CRESTVIEW SUBDIVISION DEVELOPMENT

Lane Council of Governments

Lowell Planning Commission Public Hearing

Planning Commission
Public Hearing: April 14, 2020

Conceptual Grading Plan (Sheet 2)

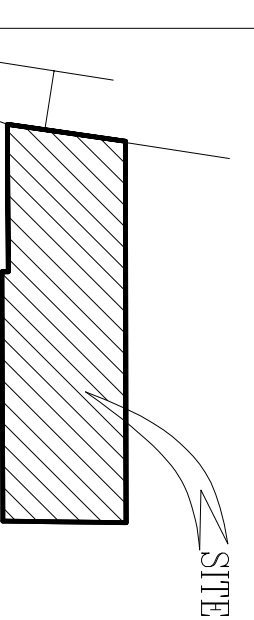
- No lot grading is shown. With up to 8' (regularly 4' – 6') of grade differential between lots, the developer should be clear about the intention of those slopes. Per the report, all slopes are 2:1 with no retaining walls, but with lots that are only 60' wide, when a 6' vertical (12' horizontal) slope is added there's only 48' left over. Given development code standard setbacks (assuming 2 stories = 7.5'), the building pad area is reduced to less than 40'. Is this realistic?

- I also think it's going to be critical to see how lots 16 & 19 are graded to see if they're viable lots. From the back of lot 16 to the back of lot 19, there's about 40' of fall. I think how these lots are going to be graded will/should impact the PC/CC discussion of allowing the flag lots.

TENTATIVE MAP FOR
CRESTVIEW ESTATES
CITY OF LOWELL
PUBLIC WORKS DEPARTMENT
SHT. 1 OF 5

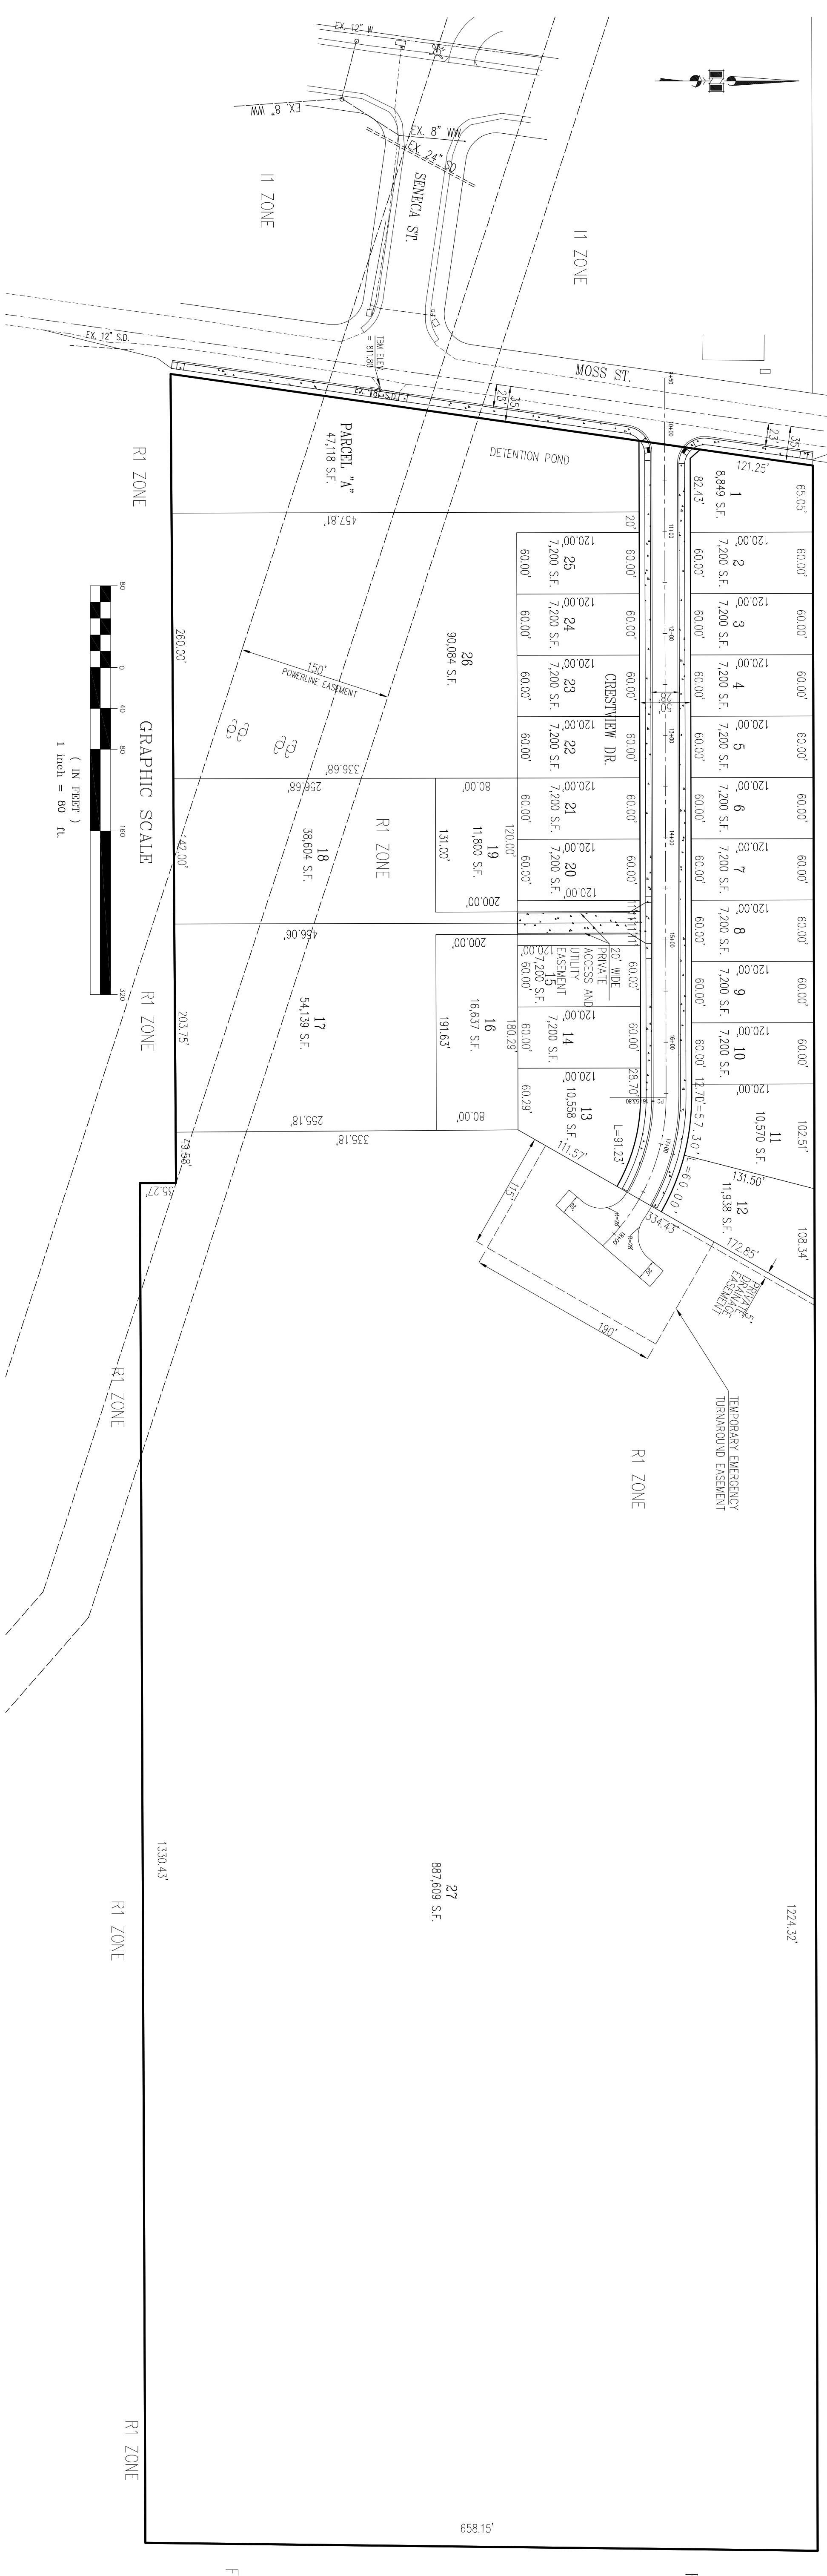
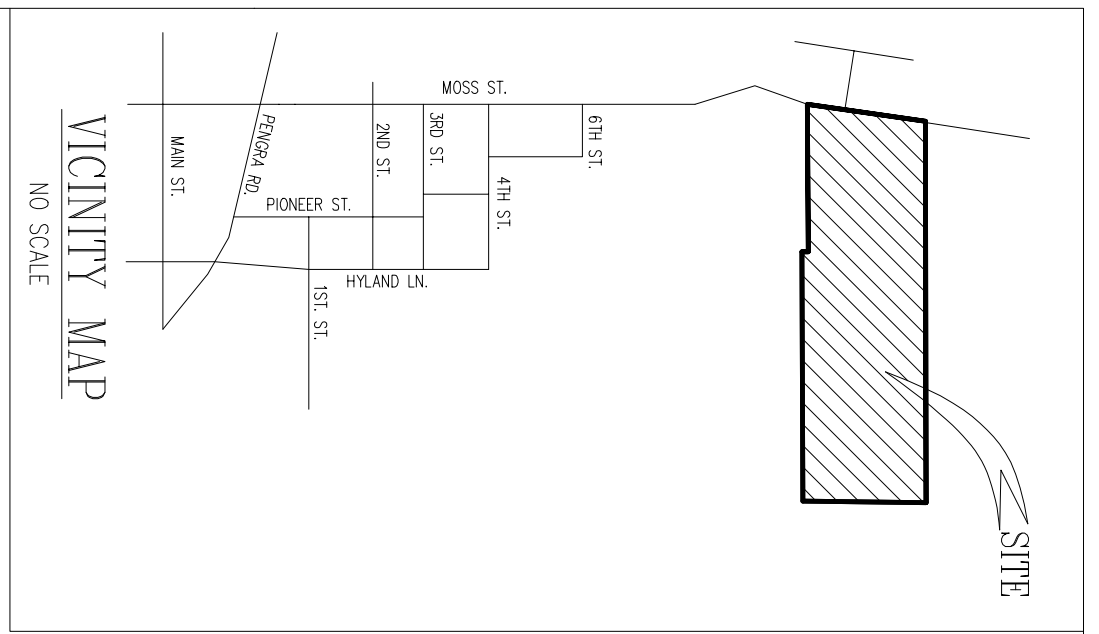
Discussion: The applicant is requesting a variance to the access standards listed above. As seen in Sheet 1, the applicant is proposing two access ways next to each other (each 11-feet in width as seen on Sheet 1) to allow four lots to use both access ways. The overall width is 44-feet with a 20-foot wide paved section. The proposed access for which the applicant is proposing is allowed as indicated in subsection (a) only if approved by the City, in which case the total width must be at least 16-feet. The road right-of-way will and required public improvements will be constructed before the individual lots are prepped for home site construction. The right-of-way and associated public improvements required are anticipated to begin following tentative approval, but after approval of more specific construction drawing plans are approved by the City.

Discussion: As seen on Sheet 1, two easements are shown in addition to the 7-foot PUE on both sides of Crestview Drive. The applicant has discovered two private access easements that exist on the unsubdivided remainder portion of the subject property. The two private access easements are used for logging purposes. The applicant will the private access easement accessible, as per the recorded easements. The private access easements are not for the purposes of any building, structure or residential development. See **Attachment Q** for copies of the private access easements. As required by LDC, the applicant shall include on the final plat all easements and shall provide all dedications, covenants, conditions, or restrictions with provide any supplemental data for review. The easements shall be consistent with Lane County recording requirements and procedures and ORS 92. There are no significant water courses on the subject property. This will be a condition of approval.

Recommended FINDING for approval: As seen on Sheet 1, the applicant proposes a 20-foot wide access easement between lots 16-19 and a 5-foot private drainage easement along the eastern property boundary of lot 12. These easements shall be shown and recorded on the final plat as with all dedications, covenants, conditions, or restrictions. The easements shall be consistent with Lane County recording requirements and procedures and ORS 92. Criterion met with the following Condition of Approval #18.

CONCEPTUAL GRADING PLAN
CRESTVIEW ESTATES

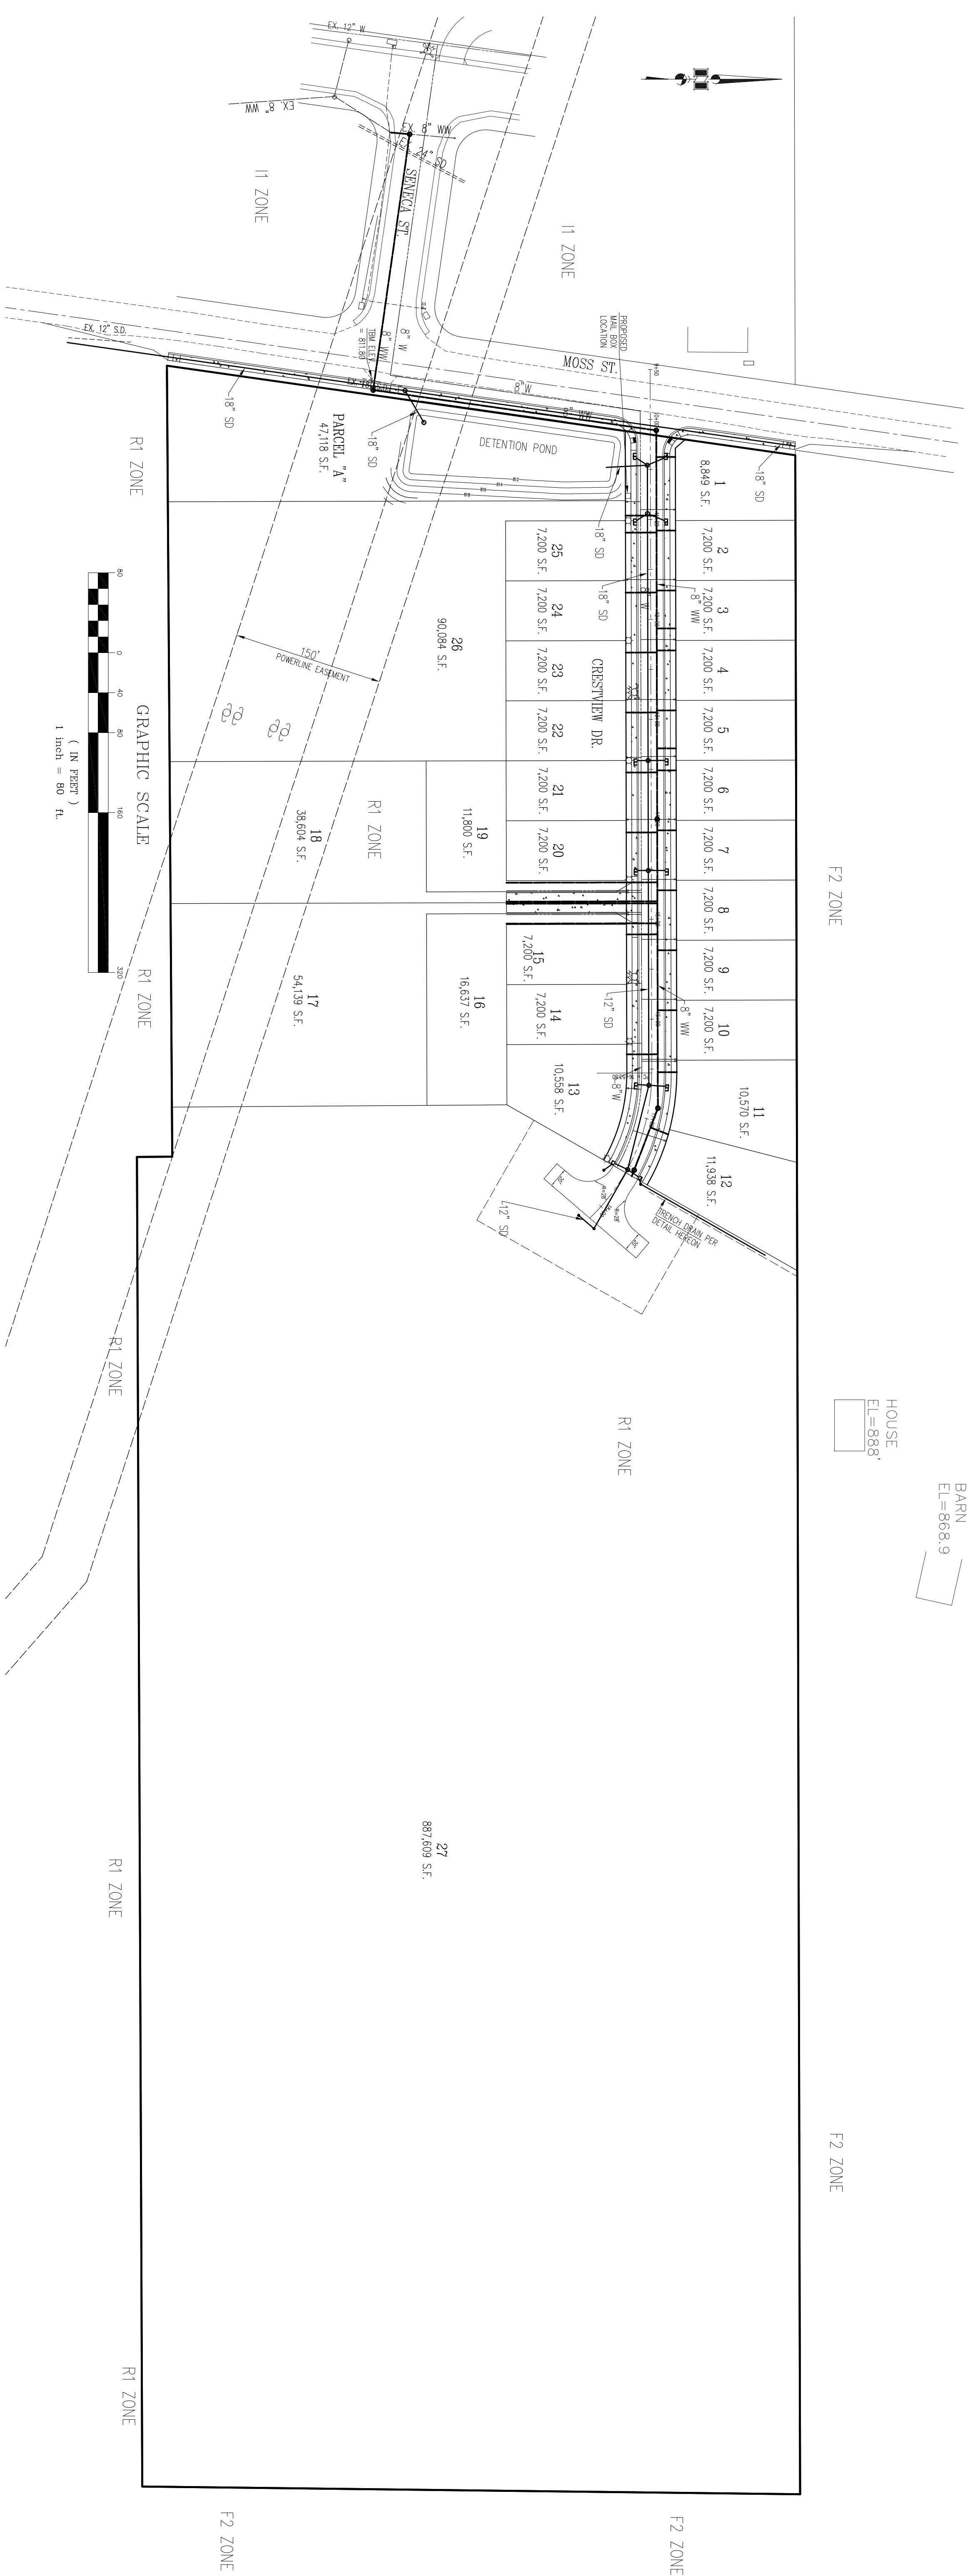
Discussion: The applicant's engineer has submitted a preliminary grading plan as seen on Sheet 2. As indicated in the applicant's response to completeness items, dated September 20, 2019, the applicant does not intend to perform any grading as part of this subdivision process. The applicant intends to sell the finished lots to home builders and it will be up to the home builders to develop a building site on each lot. The applicant's engineer recognizes that cuts and fills be necessary and will be done under the supervision of a geotechnical engineer, where appropriate. A Geotech report will be required due to the subject property containing slopes of 15 percent and greater. Additionally, a finalized grading plan will be required. Both of these requirements will be condition of approval and will be further addressed under Section 9.633(b) and (c) (2).

Discussion: The subject site does contain slopes of 15 percent or greater. The applicant has submitted a preliminary conceptual grading plan as seen on Sheet 2. The applicant will be required to submit final grading plans during the construction phase of the development for review and approval by the City Engineer. The standards listed in the Hillside Development section of LDC will largely be addressed post tentative map approval during the construction plan drawing phase of the project. The applicant will be required to submit plans to shown conformance with hillside development standards. As listed in the LDC, specific engineered plans may be required. This will be a condition of approval.

With respect to grading – the grading plan on sheet 2, is that the actual grading plan? You note in your narrative, that the applicant does not intend to perform grading, just get the lots platted and then sell to a builder for the development of home sites. Will the applicant only be performing the grading required for the public infrastructure improvements (streets, water, etc..)? **Response: A more detailed grading plan for the public infrastructure only will be prepared during the construction drawing phase. At this time we are proposing to only perform the grading necessary to build the public infrastructure. During the building permit process for the houses, the lots will need to be graded and individual grading plans will be prepared.**

SHT. 3 OF 5

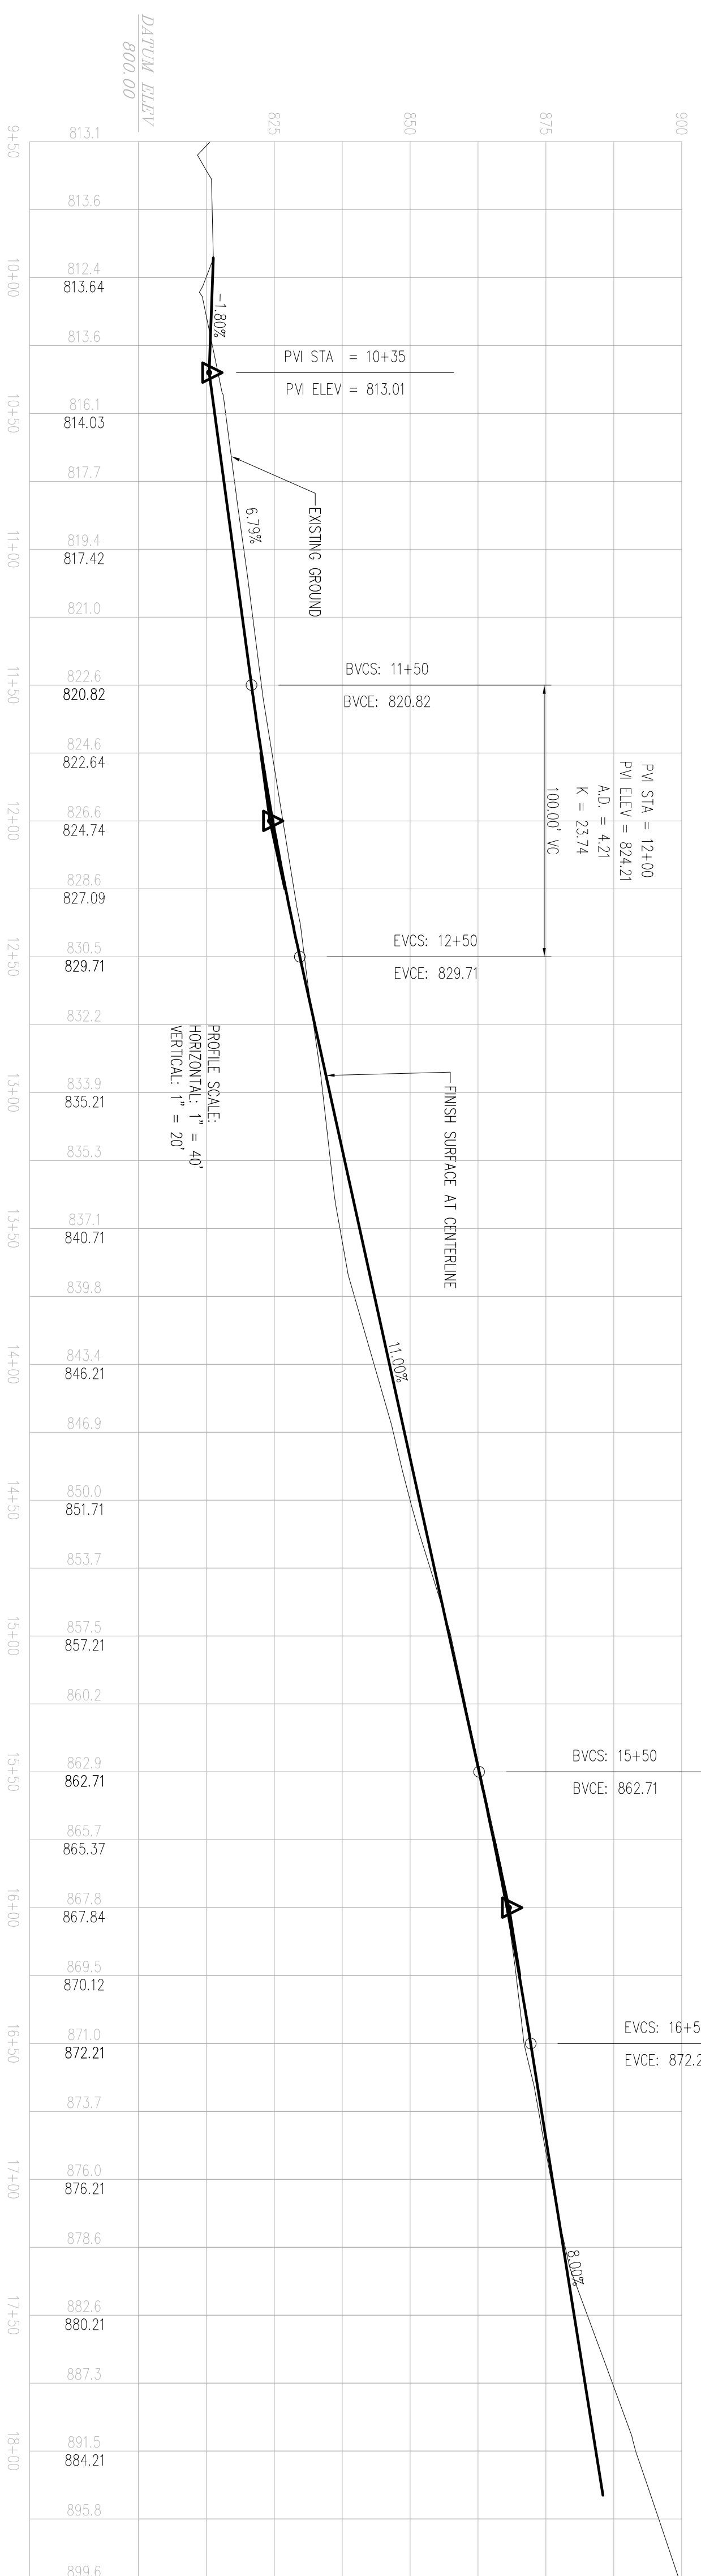
Discussion: A mailbox structure is proposed to receive mail for the eventual homes on lots 1-26, as seen on Sheet 3. However, there is no indication from the applicant that the mailbox structure has been placed as per the recommendation of the local Post Office having jurisdiction. This will be a condition of approval, prior to final plat approval.

Discussion: The applicant's engineer has provided a preliminary utilities plan as seen on Sheet 3. The plan shows that adequate connections are available or can be accessed to provide lots 1-26 with city water. However, the plans submitted on Sheet 3 are preliminary and are used to attain tentative plat approval. Final construction plans relating to water will be made a condition of approval. The applicant may choose to show all utilities (water, sewer, general utilities) on one final utilities map. The final construction plans for utilities shall be submitted for review by the City Engineer prior to any construction.

Recommended FINDING for approval: The utilities plan as seen on Sheet 3 is preliminary and provided for tentative map approval. A final utilities plan will need to be submitted for review and approval by the City Engineer prior to any construction activities commence with respect to water, sewer and utilities. Criterion met with the following Condition of Approval #16.

Condition of Approval #16: The utilities plan as seen on Sheet 3 is preliminary and for tentative map approval. A final utilities plan, consistent with LDC 9.521, shall be submitted for review and approval by the City Engineer prior to any construction activities commence with respect to water, sewer and utilities.

Condition of Approval #17: The utilities plan as seen on Sheet 3 is preliminary and provided for tentative map approval. A final utilities plan, consistent with LDC 9.522, shall be submitted for review and approval by the City Engineer prior to any construction activities commence with respect to water, sewer and utilities.
